In a letter dated December 5, 1980, from R. L. Tedesco to me, TVA was requested to provide additional clarification with respect to the Watts Bar Nuclear Plant Containment Vessel Building Analysis. Enclosed is the requested information.

WATTS BAR NUCLEAR PLANT UNITS 1 AND 2  
CONTAINMENT VESSEL BUILDING ANALYSISIntroduction

FIG 6  
GOVERNING BUCKLING RATIOS

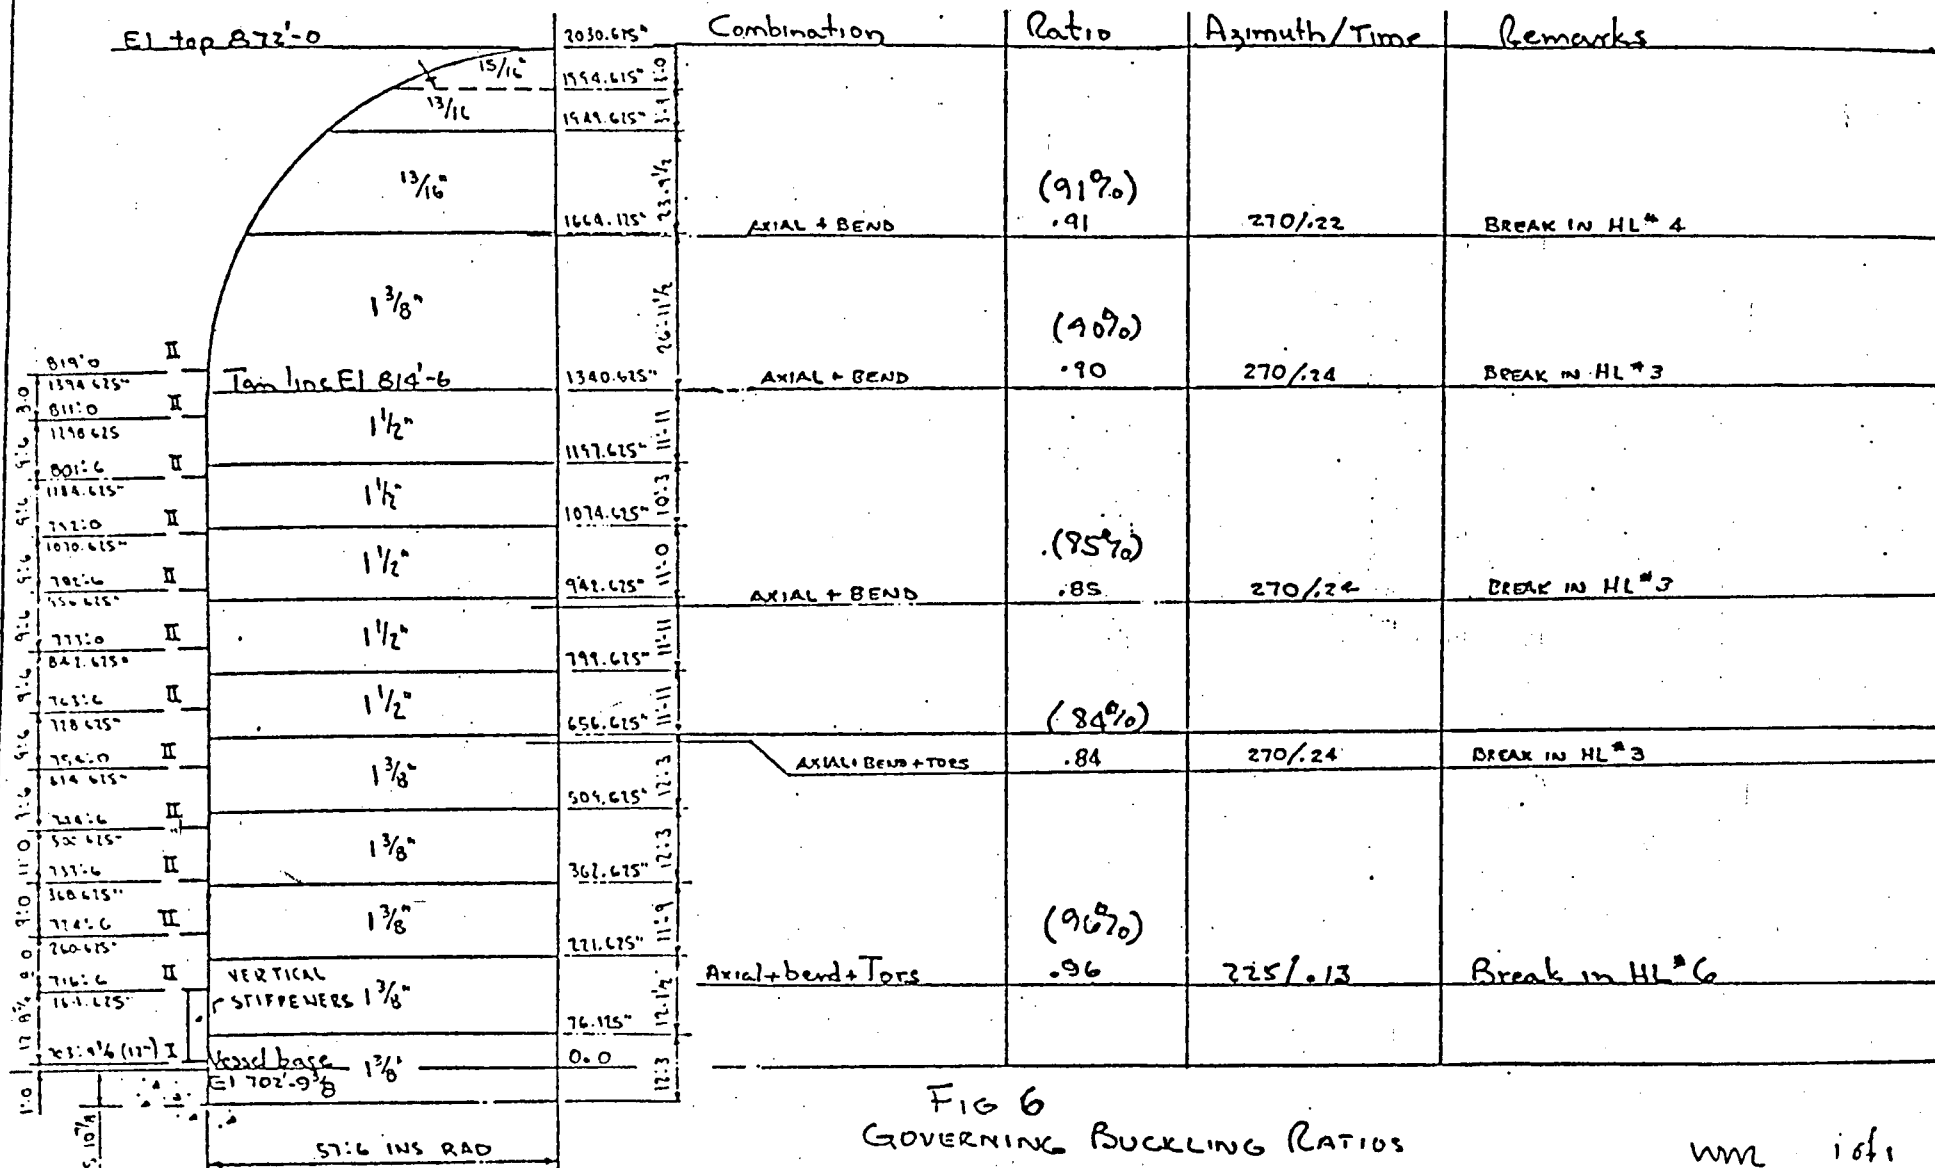
Figure 6 (copy attached) of the response to the original questions shows that the buckling ratios were less than 1 for all areas of the general shell. The additional membrane compressive stresses in the area of the locks and hatch due to the local response of the locks and hatch will be less than or equal to the maximum membrane ( $P_m$ ) "inertial stress" of  $1.6 \text{ k/in}^2$  shown in table 1. Even if this maximum compressive stress is multiplied by a factor of 2, it will still be much less than the incremental allowable buckling stress of  $5.2 \text{ k/in}^2$  (14.9 - 9.7) between the local area around the locks and hatch and the general shell. Therefore, the buckling ratio of the shell in the area of the locks and hatch is less than 1 and this area of the containment meets the specification buckling criteria.
